INDESIT company

INC310GAID

Commercial code:

F031400

0522067: SEALS FOR DOORS FOAMED AS ONE PIECE

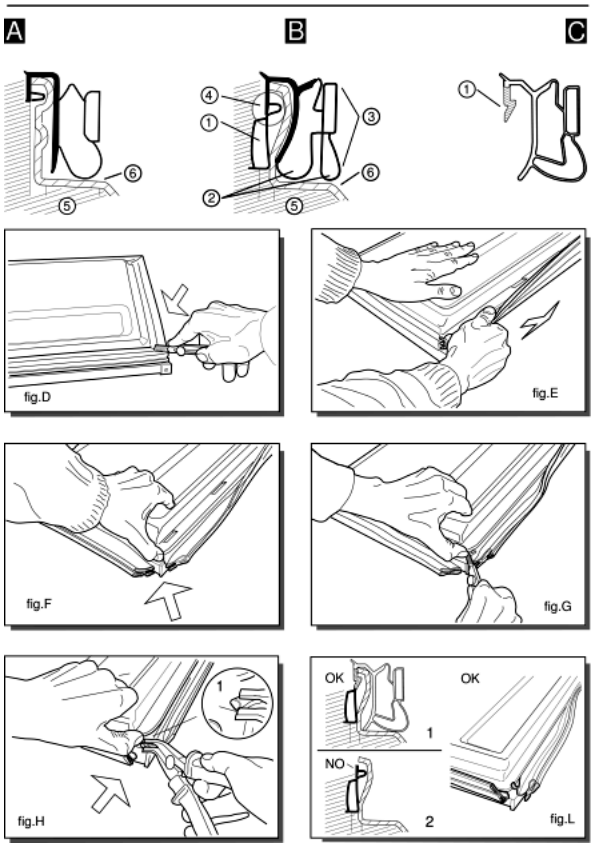
Various types of gaskets with different profile, as shown in figures (A) and (B), are used to fix the door (fig. A-5; B-5) and the inner door (fig. A-6; B-6) on the block foamed doors of combined freezers and refrigerators.
---Ilpea profile 245; 179; 412 (fig.A)
---Ilpea profile 287 (fig.B)
When replacing gaskets with profiles 245; 179; 412 these are fixed with screws (2 per corner) to the door.
Gaskets with profile 287 can not be used as spare parts but are designed to house the Ilpea type 900 gaskets (see figure C).
When replacing the gasket (287), once it is removed you will find a pocket (fig. B-1) between the door and inner door.
The rigid tooth (fig.C-1) of the gasket (900) is inserted inside between the pocket and the inner door, doing away with the need for screws.
Gasket with profile 287 is easy to identify since it has an exterior double edge (fig.B-2) which acts as a cushion when the door is closed.

To replace this gasket, follow these steps:
---Dismount the door and cut the four corners of the gasket along the joint (fig.D);
---lift the gasket and pull it carefully along its full length without tearing it (fig.E).
The purpose here is to detach the inner door slightly from the foam along the exterior edge for a depth equal to that of the gasket (fig.B-3);
---lift the corner of the inner door slightly, prising it up with your thumb (fig.F). Do not use a tool which might break the inner door;
---continue cutting the gasket inside the inner door for about 6 mm (fig.G);
---push in the tip of the pliers (type USAG N131) and pull outwards until you see the top edge of the pocket (fig. B-4) which is empty (fig.H-1);
---if you carry out this operation correctly (fig.L) you will be able to pull off the top edge of the pocket for the full length of the door.
If the gasket tears before the top edge (fig. L-2) you should repeat this operation from the other corner of the door.

---once the gasket (287), has been removed the space above the pocket (fig. L-1) can house the rigid tooth (fig. C-1) of the gasket 900.
When you fit this gasket ensure that it lies flush against the edge for the full length of the door.
If the rigid tooth is difficult to fit, eliminate any residues of foam between the door and the inner door in the gasket area.
fig.5131549A

n1030091: New control moulding on built-in mechanical 310 litre Indesit fridge-freezers

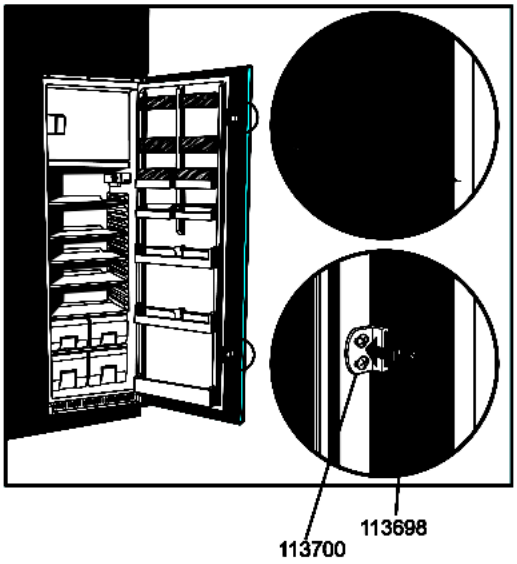
In June 2005 (serial no. 50606.0001) the Carinaro factory modified the control moulding on built-in 310 litre Indesit fridge-freezers (mechanical), unifying it with that of the electronic version in fixing and eliminating the control support.
The new moulding cannot be fitted on premodification models because also the control box and thermostat knob have been modified.
The moulding is fixed with two screws that are accessed by removing the hole covers.

118930 - CONTROL MOULDING LXHXD 328X60X22 (1-HOLE) INDESIT
099226 - THERMOSTAT KNOB WHITE
088521 - CAP RH WHITE
088522 - CAP LH WHITE

082176 - CONTROL MOULDING LXHXD 328X60X21 (1-HOLE) INDESIT
064626 - THERMOSTAT KNOB WHITE
064613 - CONTROL SUPPORT LXH 328X56X10
